Canyon Creek PD Amendment No.11

ZON2025-00001

ZON2025-00001 Canyon Creek PD Amend. No.11 (F5) 1st Review

To: Harry Brennan, Senior Planner
From: Chad Schroeder, P.E. , Development Engineering Supervisor
Date: August 29, 2025
Re: ZON2025-00001 Canyon Creek PD Amendment No.11 (Filing 5) 1st Review

DEVELOPMENT PLAN
SHEET 2 OF 8

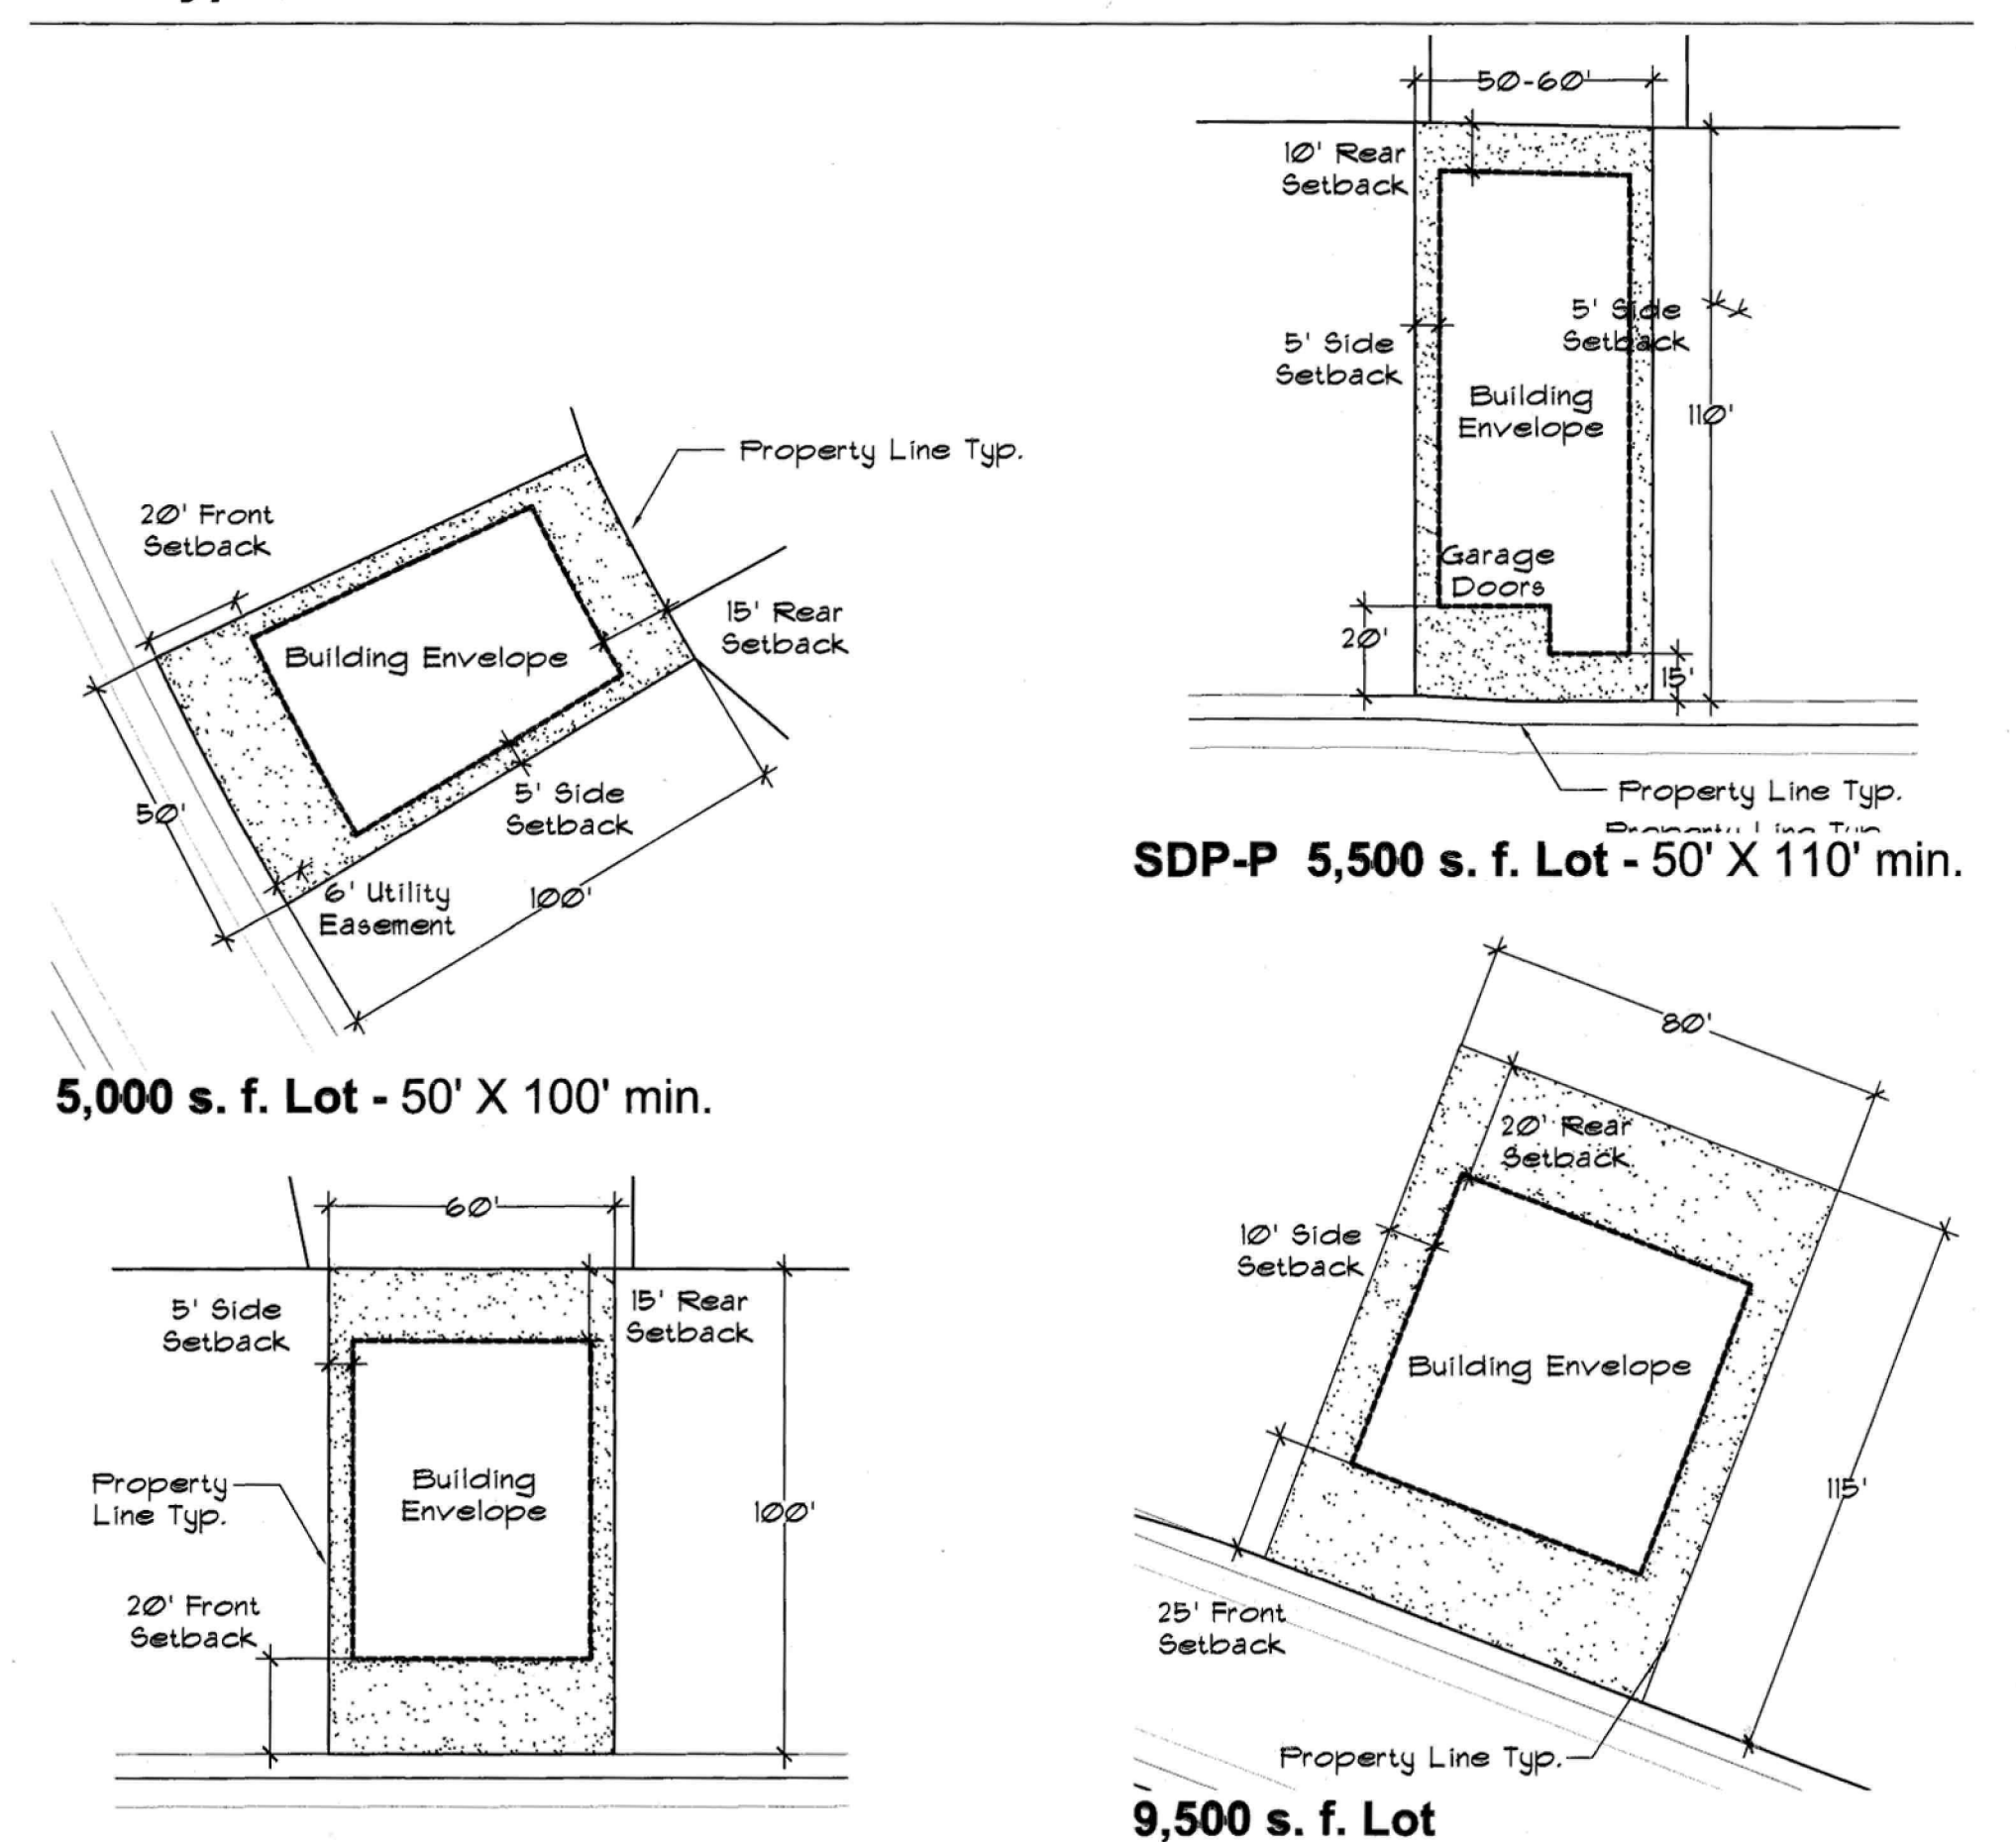
Food and Beverage in Filing 5

Filing 10 is no longer in this PD, so if we could remove it from the table that would be helpful cleanup

Filing 10 is no longer in this PD, so if we could remove it from the table that would be helpful cleanup
